Two-stroke

ME Engine Control System Software version 1909-15 (MPC) Identified issues potentially affecting engine operation

Owners and operators of Everllence B&W two-stroke marine combustion engines
Types: ME-engines with software version ME-ECS-SW-1909-15

False 'Exhaust Valve Closing Too Slow' alarm

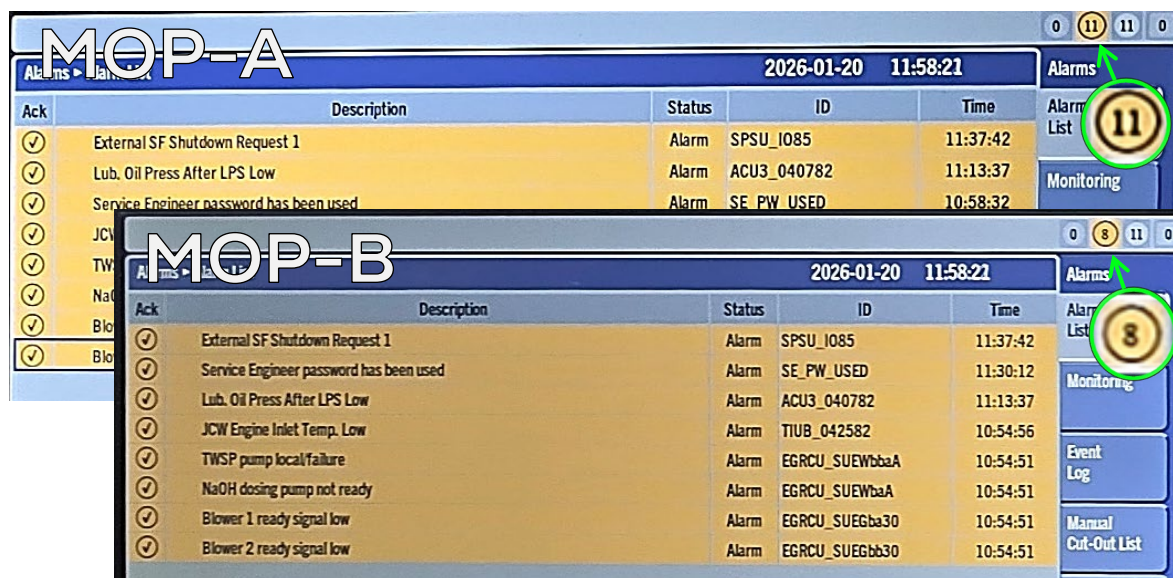
A weakness in the exhaust valve supervision algorithm may cause false alarms of this type to be emitted when the engine is running at speeds below dead-slow, e.g. during windmilling.

At low engine speed, the supervision algorithm has a tendency to over-estimate the exhaust valve close delay, depending on the shape of the measured exhaust valve position signal. This over-estimation leads the system's delay compensation function to reach its positive adjustment limit, which causes the alarm to be raised.

The defect will be resolved by a new software that reduces the likelihood of delay over-estimation and automatically cuts out the alarm when the engine speed is below dead-slow.

We recommend that if alarms of this type occur, while the engine is running at speeds below dead slow, they be acknowledged and no further action taken.

Start blocked temporarily after restarting MOP

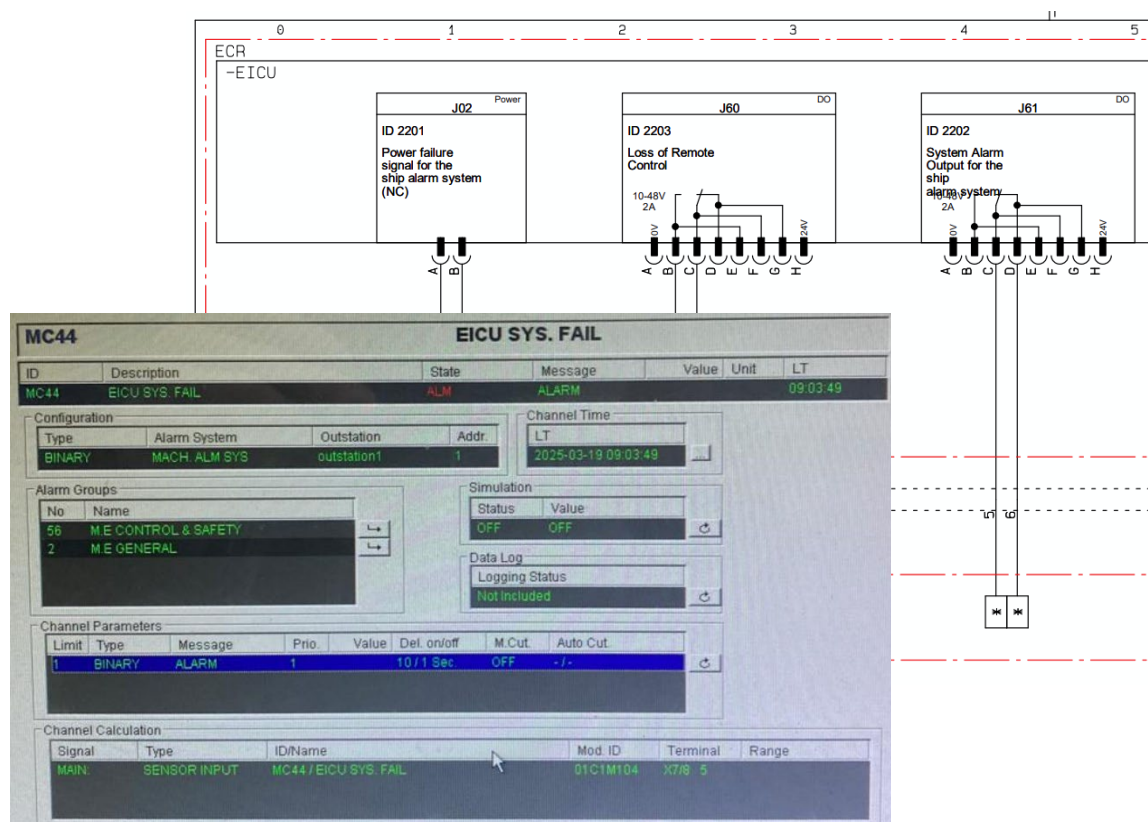
The redundant Control Network is designed to be resilient against restarting of MPC and MOP units. However, we have observed that the restart of a MOP unit, whilst the engine was stopped, has caused packet loss. Such packet loss may cause alarms of the type 'No HPS & blower feedback from ACUx' to be raised and a temporary 'start blocked' indication to occur.

The issue has been reproduced in the laboratory, but the underlying defect has yet to be identified.

We recommend that MOP units only be restarted when the engine has been stopped and that network-related alarms raised during the restart be just acknowledged and no further action taken.

Common alarm relay toggling without active alarm

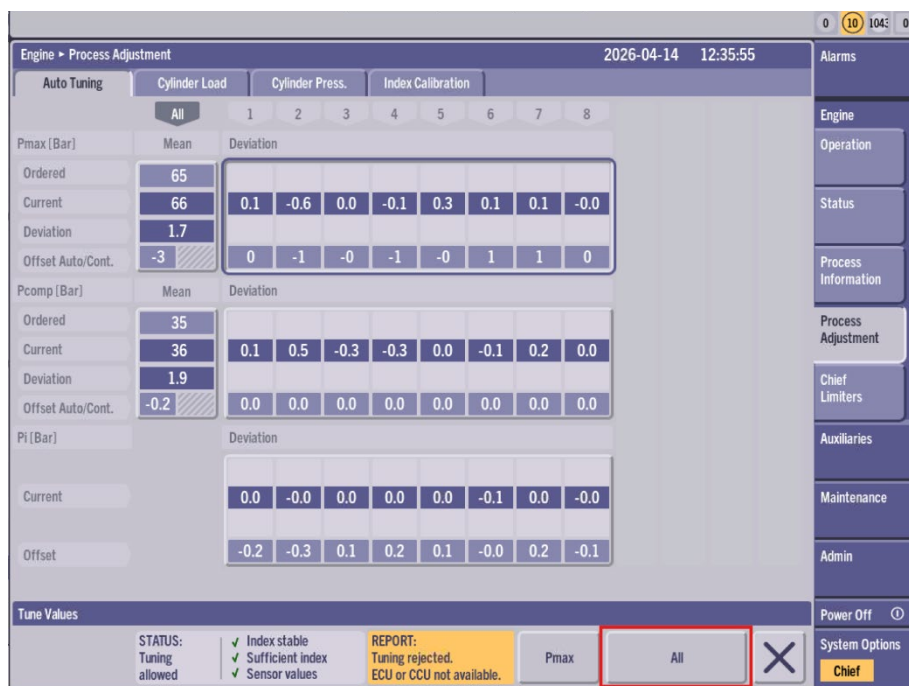
The common alarm output relay J61 on the EICU units can get into a state in which it toggles even if there are no unacknowledged alarm channels in the system.

We are still working to re-create the problem in the laboratory, and the underlying defect has not yet been identified. But, we still believe to be able to provide a fix in the next software release.

If this situation should arise, we recommend that both EICU units be power-cycled at the earliest convenience with engine stopped. If that does not resolve the issue, then we recommend that all MPC units be power-cycled with the engine in Finished With Engine (FWE). If this latter action does not help, please contact us.
